Subject: Supplemental Information to WCAP-17524, "AP1000 Core Reference Report" to Address Thermal Conductivity Degradation (Proprietary/Non-Proprietary)

Subject: Westinghouse Response to NRC RAIs on WCAP-17524, "AP1000 Core Reference Report"
(Proprietary/Non-Proprietary).

**Westinghouse Response to NRC RAIs on WCAP-17524, “AP1000 Core Reference Report”
(Non-Proprietary)**

Figure 15.6.5.4A-3

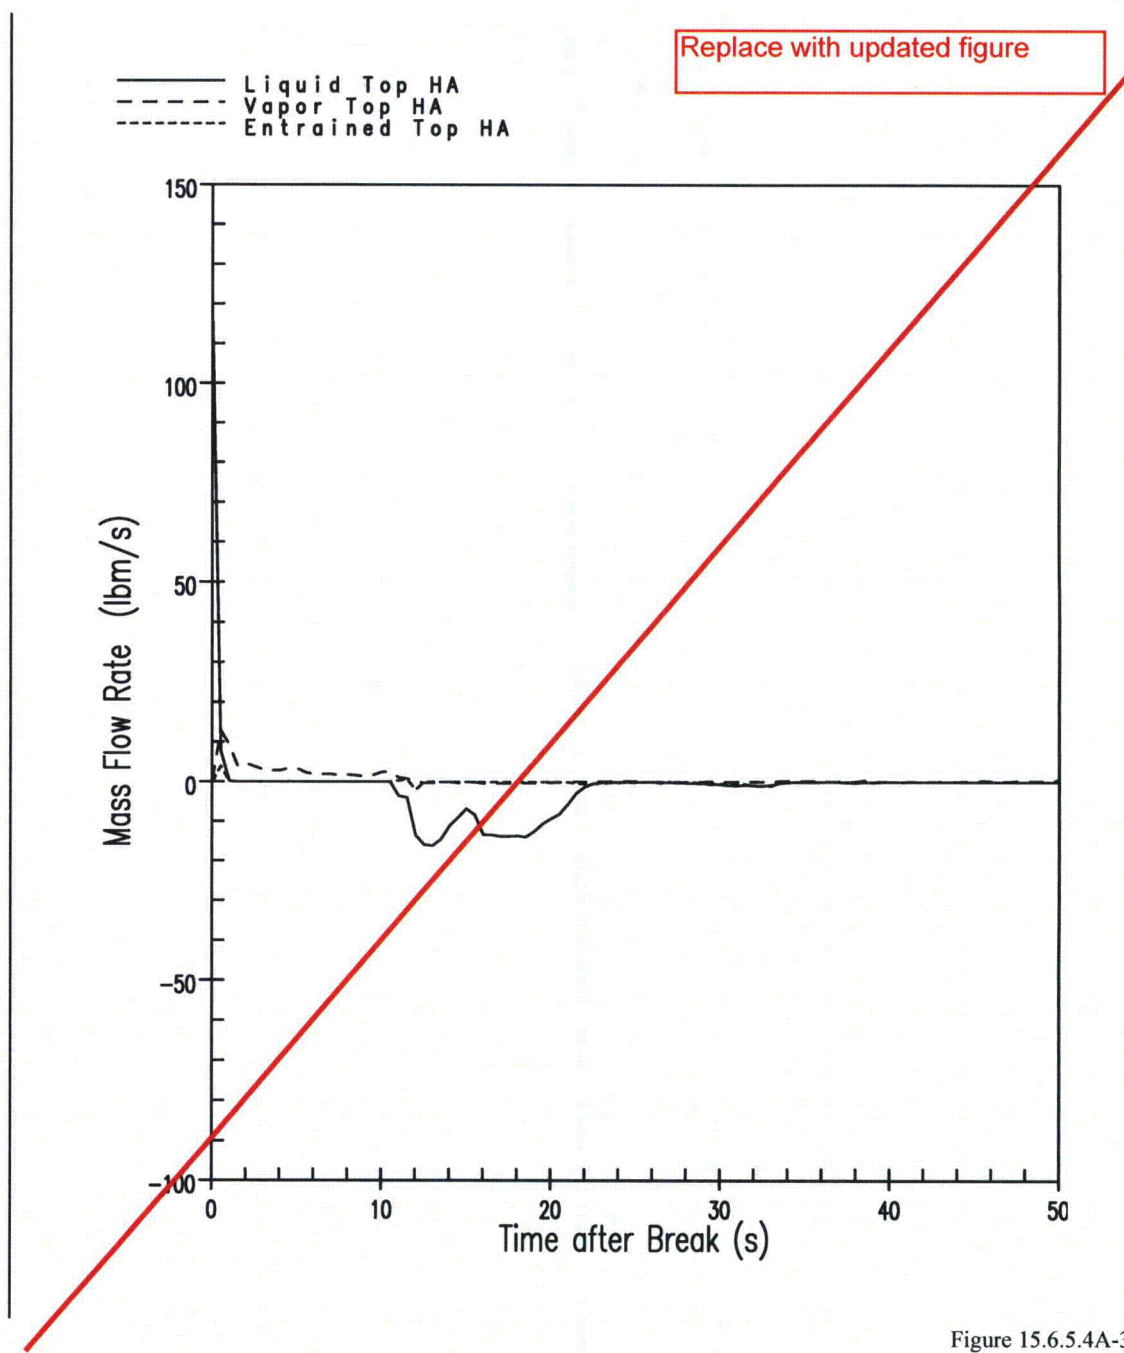
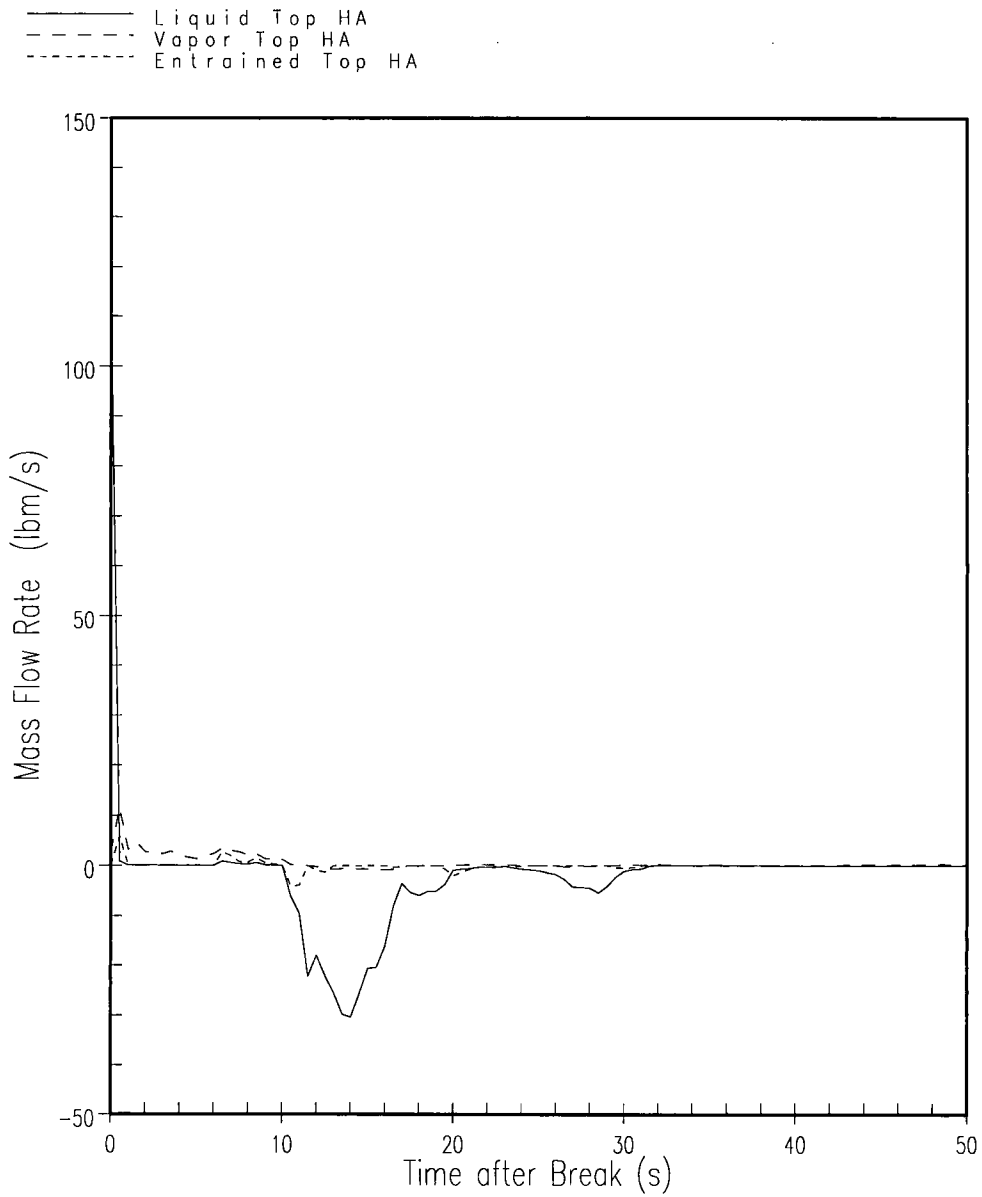
A description of the limiting PCT/~~MLO~~ case from the AP1000 ASTRUM analysis follows. The limiting PCT/~~MLO~~ case is a double ended guillotine ~~split~~ break. The sequence of events is presented in Table 15.6.5-6. The break was modeled to occur in one of the cold legs in the loop containing the core makeup tanks. After the break opens, the vessel rapidly depressurizes and the core flow quickly reverses. The hot assembly fuel rods dry out and begin to heat up (Figures 15.6.5.4A-1 and 15.6.5.4A-2) after the initial flow reversal (Figure 15.6.5.4A-3).

Figure 15.6.5.4A-4

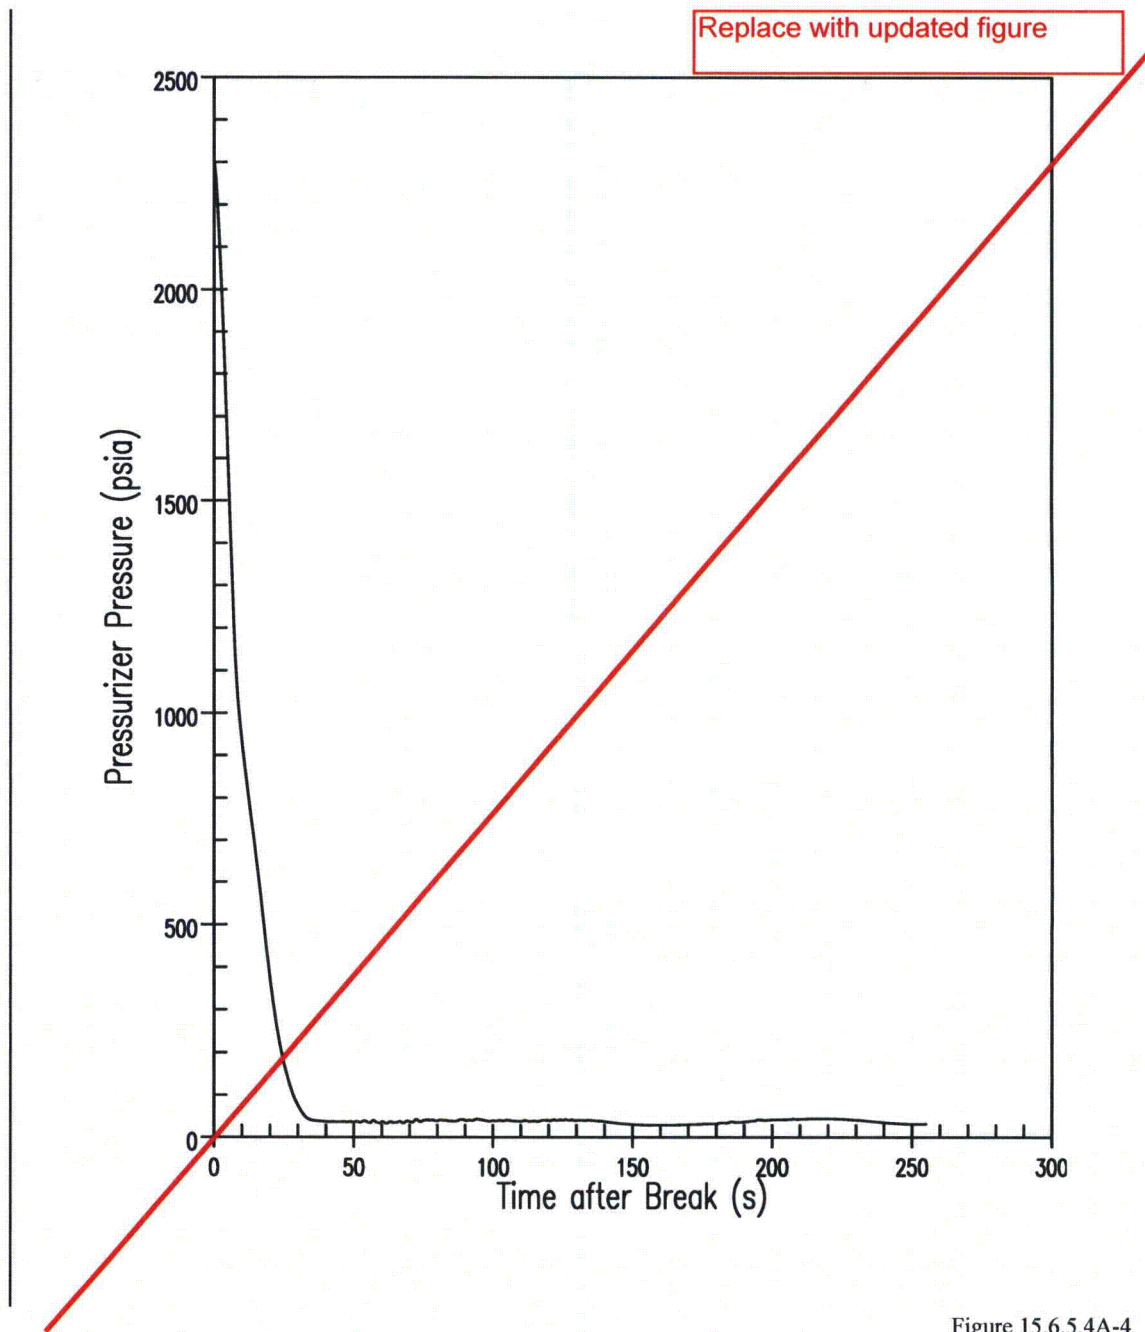
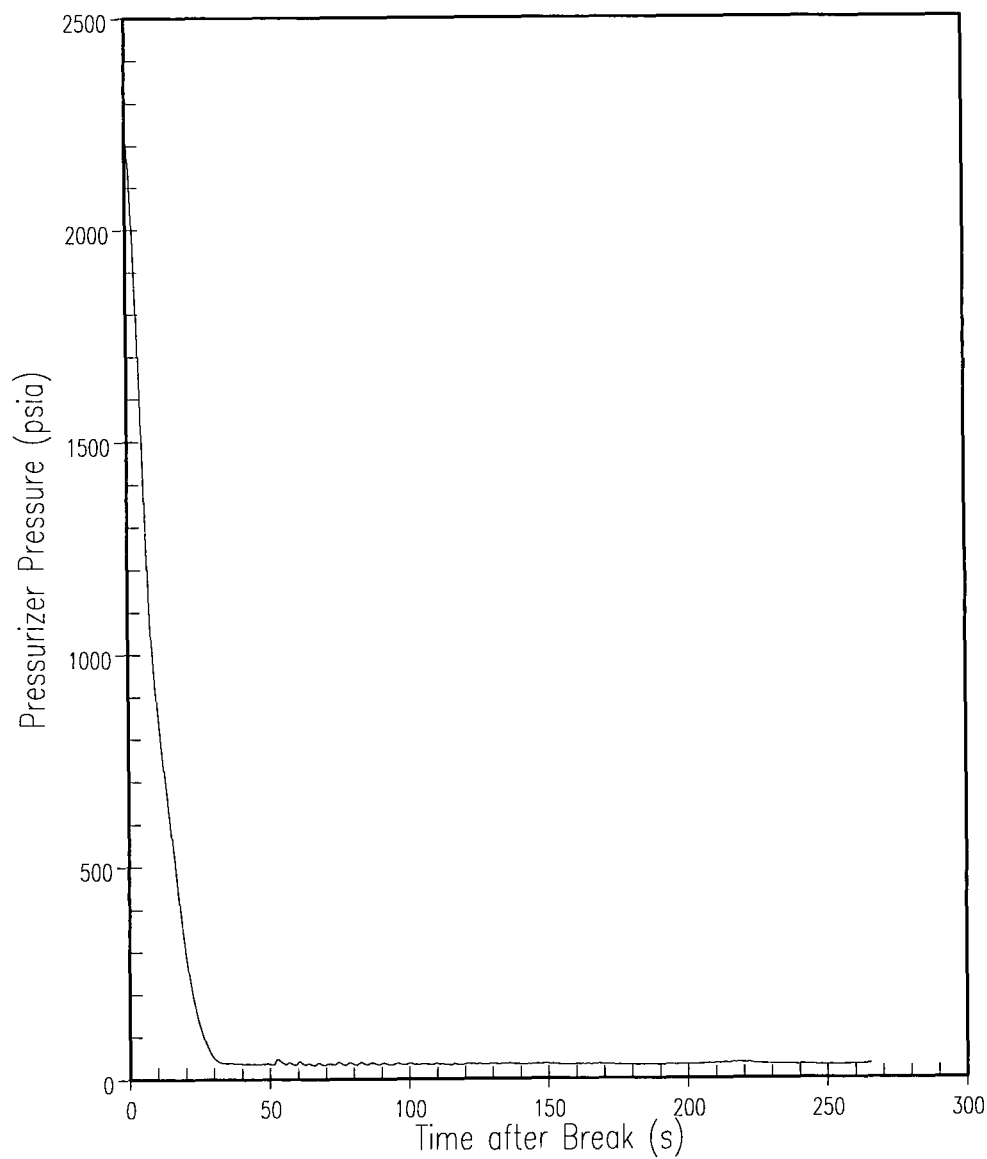
The system depressurizes rapidly (Figure 15.6.5.4A-4) as the initial mass inventory is depleted due to break flow. The pressurizer drains completely approximately 30 seconds into the transient, and accumulator injection commences 13 seconds into the transient (Figure 15.6.5.4A-5). Accumulator actuation shuts off core makeup tank flow (Figure 15.6.5.4A-6), which has been occurring since the isolation valve opened. The CMT liquid level remains well above the ADS Stage 1 actuation setpoint throughout the AP1000 LBLOCA cladding temperature excursion, even though CMT injection begins again around 190 seconds.

Figure 15.6.5.4A-7

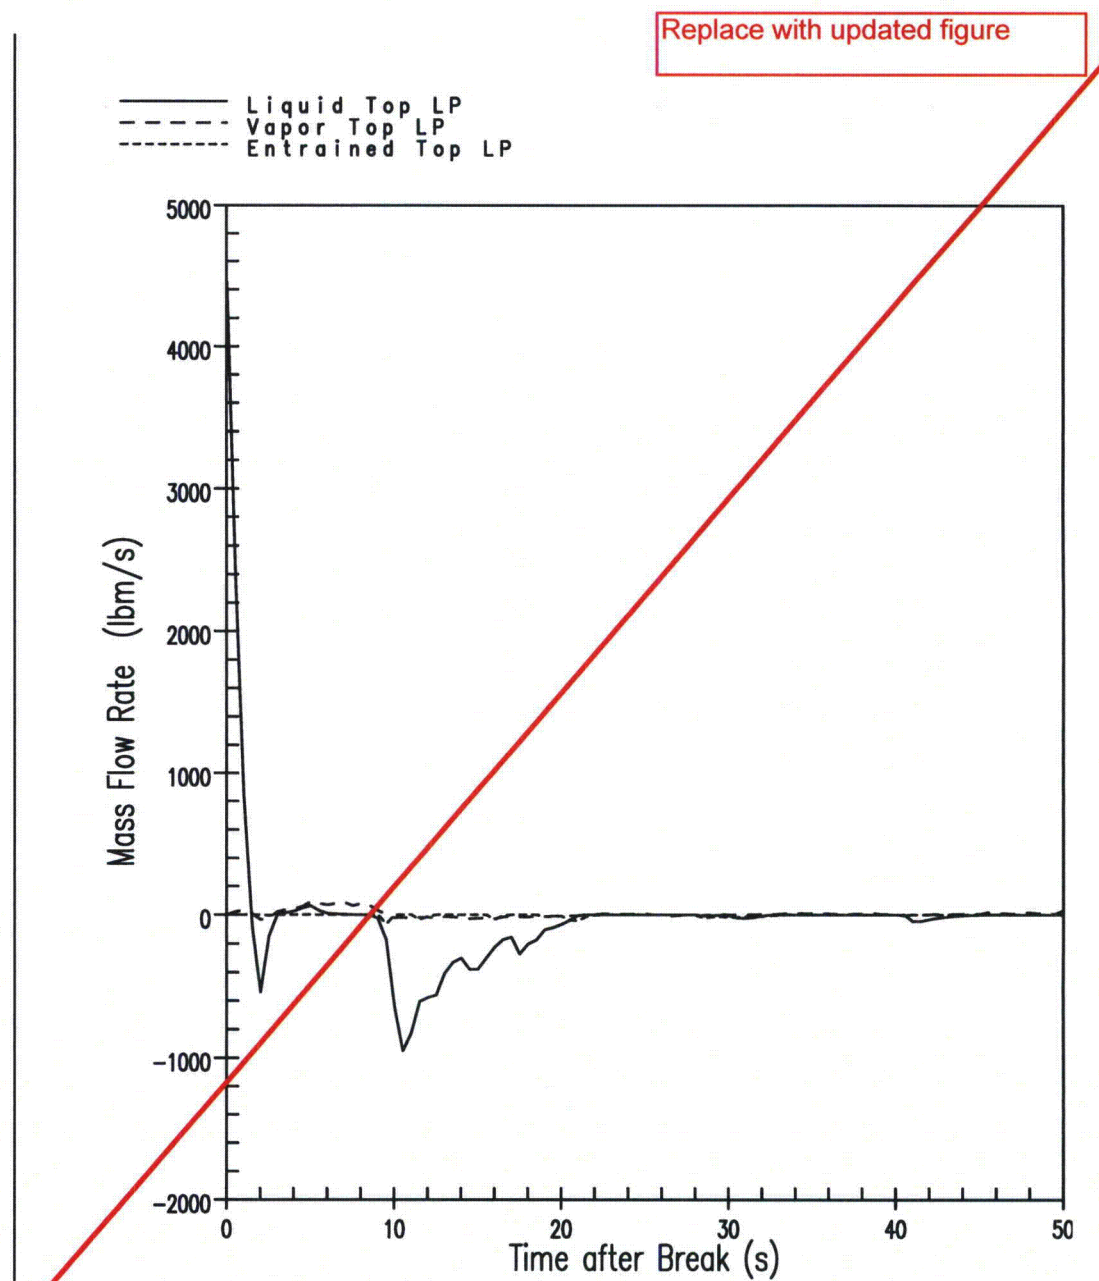
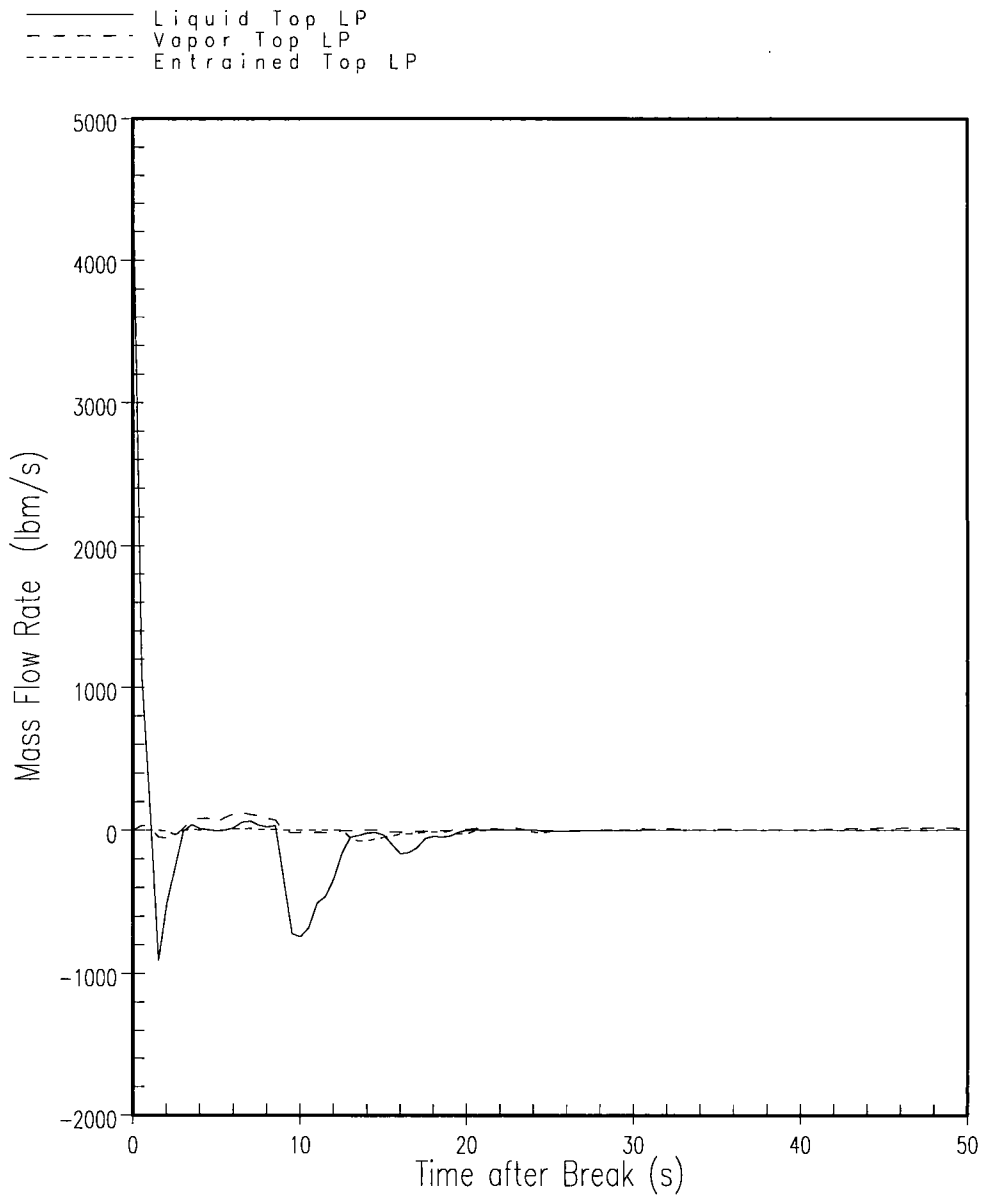
Figure 15.6.5.4A-7 demonstrates that liquid downflow exists through the top of the peripheral core assemblies from approximately 1 to 3 seconds and again from 9 to 21 seconds in the 95th percentile estimator PCT/MLO case. The power of the fuel in this region is significantly lower than that of the fuel in the open hole/support column and guide tube locations (Table 15.6.5-4), so liquid downflow occurs earlier on the periphery than in the average power assemblies.

Figure 15.6.5.4A-8

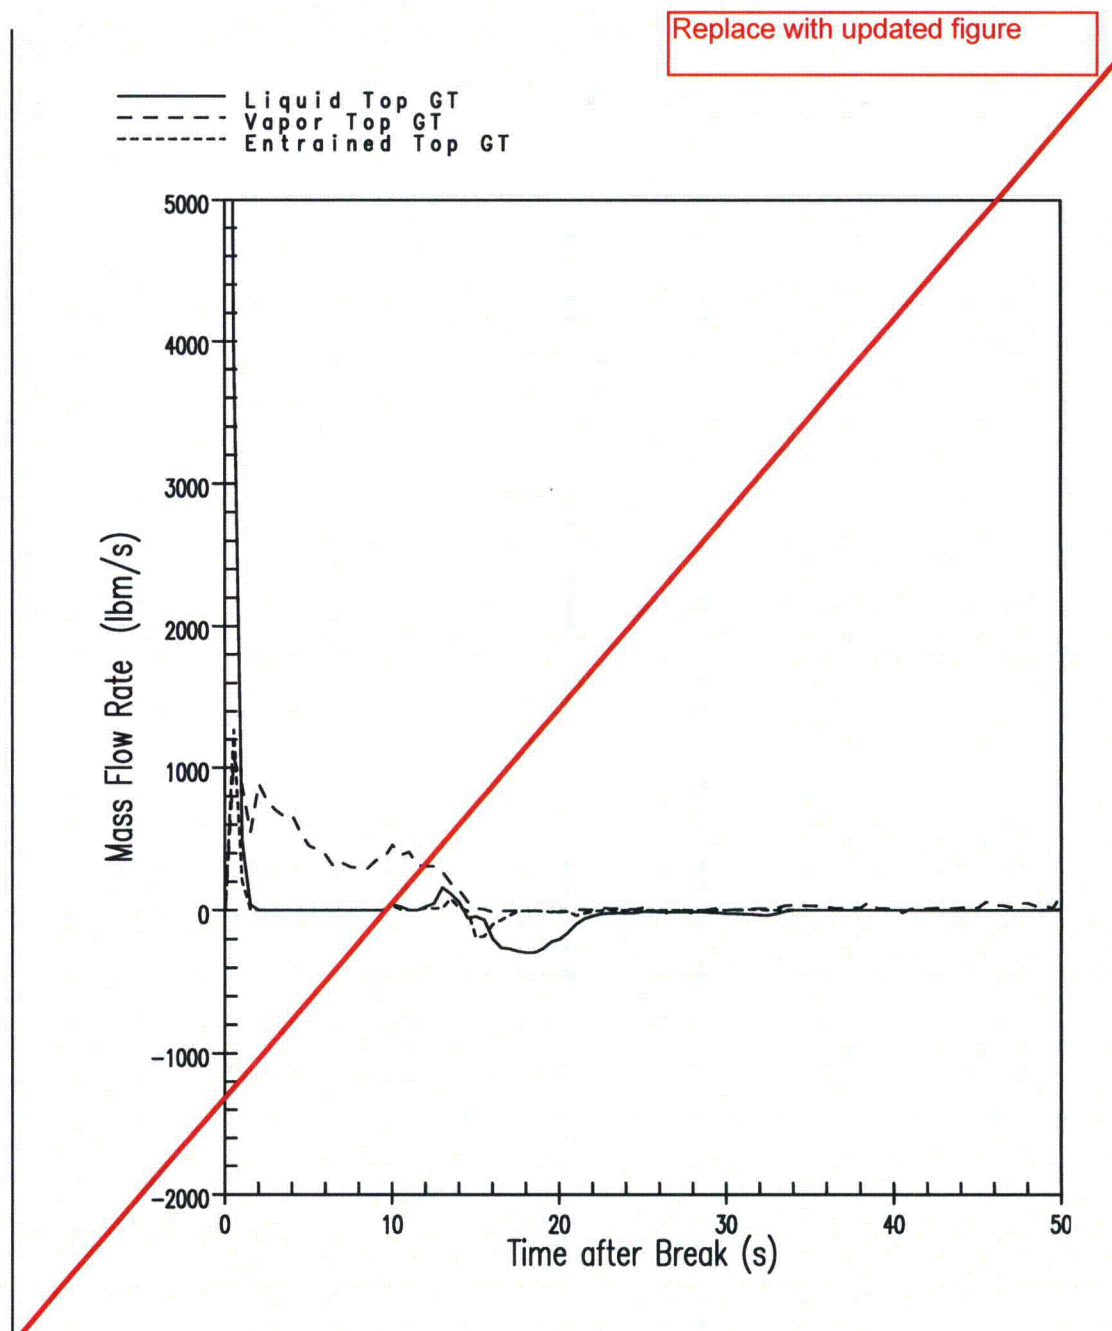
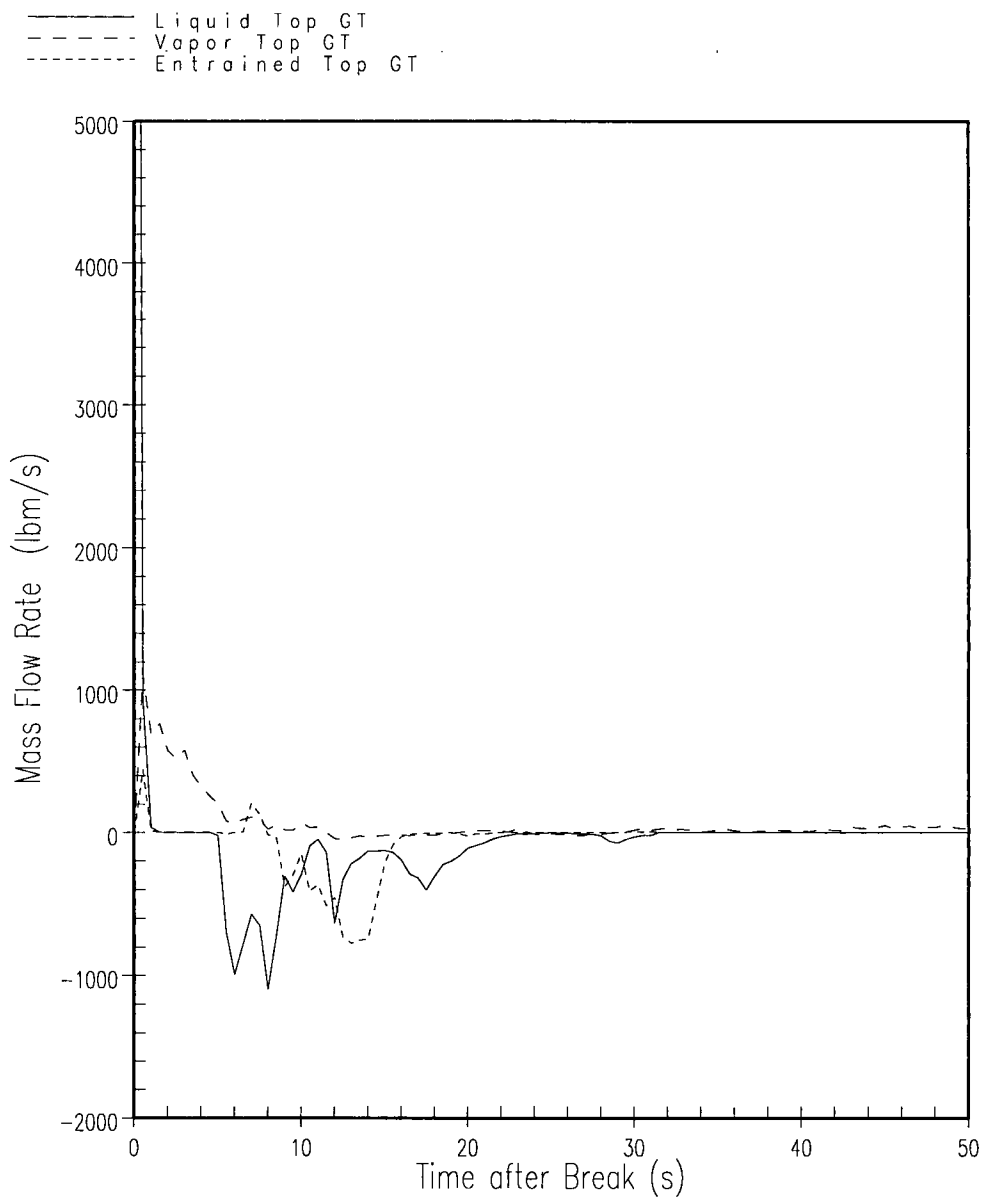
Once the upper head begins to flash, liquid drains directly down the guide tubes and that fraction that is able to penetrate into the core does so, at a maximum flow rate exceeding 1000 lbm/sec of total liquid flow between 5-23 seconds (Figure 15.6.5.4A-8).
